Our Case Number: ABP-317560-23

Re: Proposed windfarm development including 13 no. wind turbines in Bunnyconnellan, Co. Mayo and hydrogen plant in Castleconnor, Co. Sligo.
Carrowleagh, Bunnyconnellan, Co. Mayo and Curraun, Castleconnor, Co. Sligo.

Re: ABP -317560-2324

Proposed windfarm development including 13 no. wind turbines in Bunnyconnellan, Co. Mayo and hydrogen plant in Castleconnor, Co. Sligo.

Figure 3: Hydrogen Plant elevations showing re-profiled landscape immediately adjacent

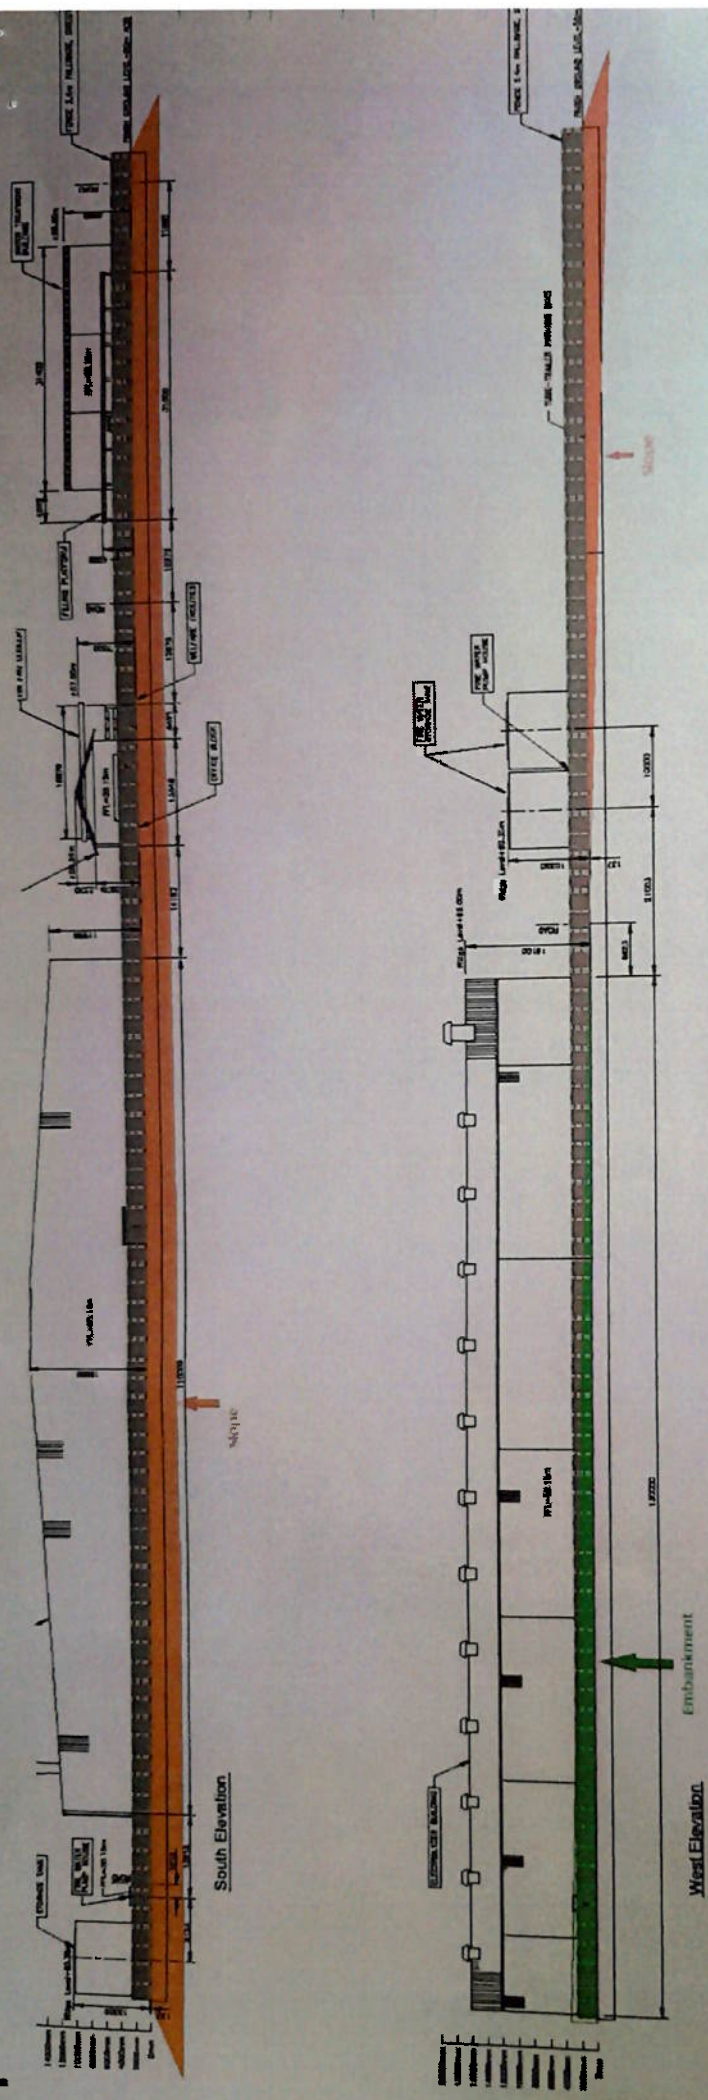
There was no profile erected for the Hydrogen Plant buildings, and the virtual wireframe montage does not clearly represent the proposed development or topography. The scale of the building on the video on mercuryrenewables.ie/hydrogen is very misleading.

We omitted to enclose the attached drawing of Hydrogen Plant elevations
Please find the said file attached.
